AMENDMENTS TO THE DRAWINGS:

TITLE: DISPLAY SUPPORTING APPARATUS
INVENTORS: You-sub LEE et al.
SERIAL NO.: 10/695,351
DOCKET NO.: 1572.1137
ANNOTATED SHEET

FIG. 5

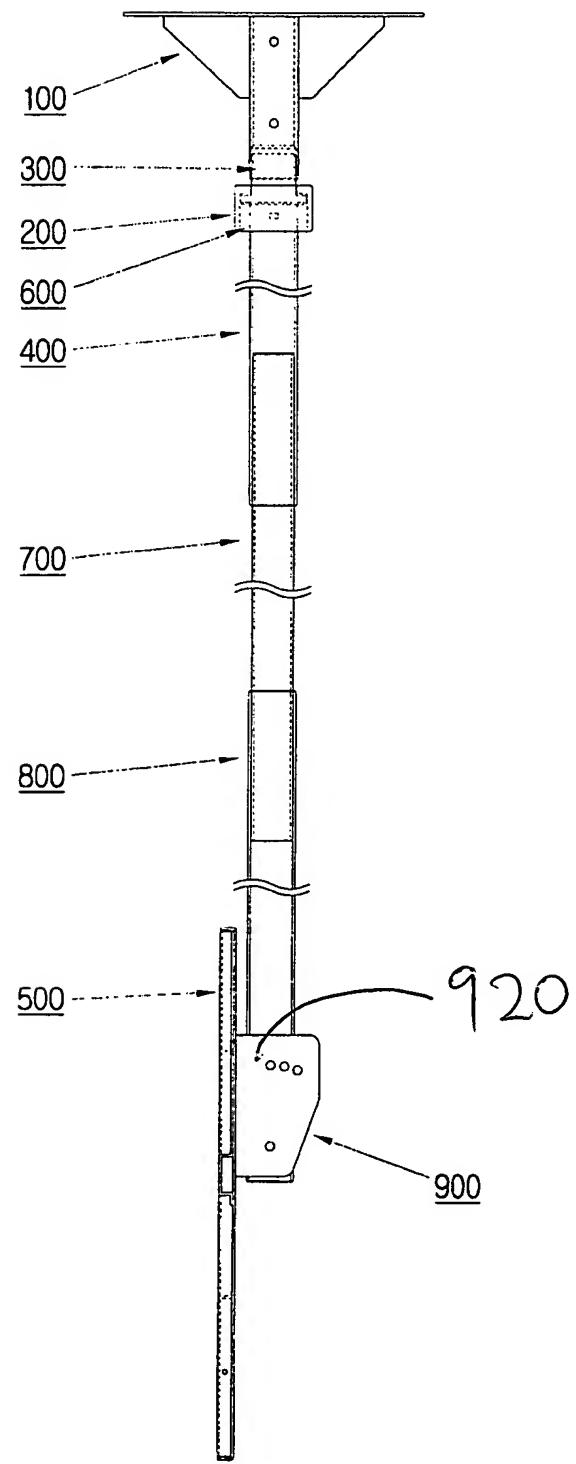
The drawings are objected to because they fail to show bend [bent] parts. In order to overcome these objections, replacement figures are submitted herewith.

In FIG. 4, bent parts were shown and described at, e.g., Paragraphs 59 and 61, but not labeled in Figs. 5, 6A, and 6B. Accordingly, the replacement Figs. 5, 6A, and 6B label the bent parts on the tilt adjusting part 900 with reference number 920.
